VEHICLE RECALL

AMERICAN TRANSPORTATION RECALL # 01303
NHTSA RECALL # 01V-269

SUBJECT: VEHICLE RECALL
Flip Seat Support Binding

Picture Showing Cushion Frame Support Bar Ready to Slip Off Seat Support Tab

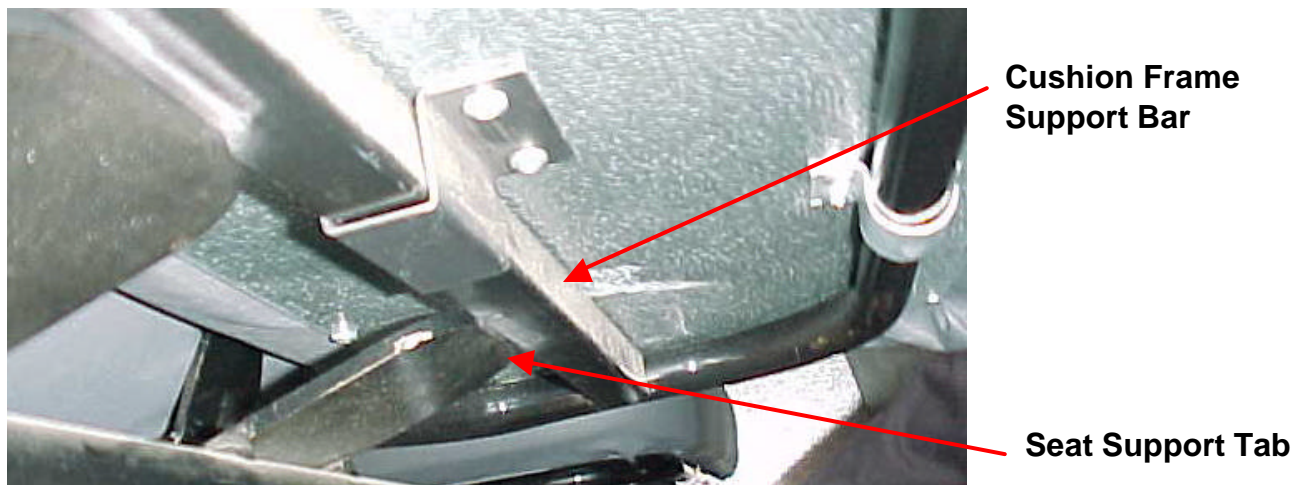
The cushion frame support bar slides off the seat support pad. When this occurs, the tabs can wedge against the support bar, which may retain the seat in the occupied position.

PICTURE SHOWING REPAIRED SEAT WITH "Z" BRACKET

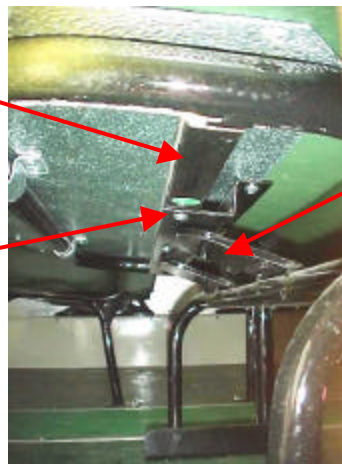
The repair procedure involves adding a "Z" shaped bracket to the underside of the seat. The following steps must be followed to repair the defect. **(WARNING: PROPER EYE PROTECTION MUST BE WORN WHILE OPERATING POWER TOOLS.)**

- Remove the existing seat retaining clip.
- The "Z" shaped bracket must be attached to the "Cushion Frame Support Bar" and the bottom side of the seat. The short leg of the bracket must face the rear of the seat. The bracket must be centered width wise on the "Cushion Frame Support Bar". The front edge of the bracket should align with the front face of the "Cushion Frame Support Bar". Make sure that the bracket will contact both "Seat Support Tabs".
- Using the holes provided in the bracket as a location guide, use a # 16 (0.1770) drill bit to drill three holes in the "Cushion Frame Support Bar" and three holes in the seat cushion plywood base. (Caution Do not drill completely through the plywood.)
- Install the supplied screws in all six holes.
- Complete and return the self addressed "**RECALL REPAIR REPLY CARD**" included with the kit.
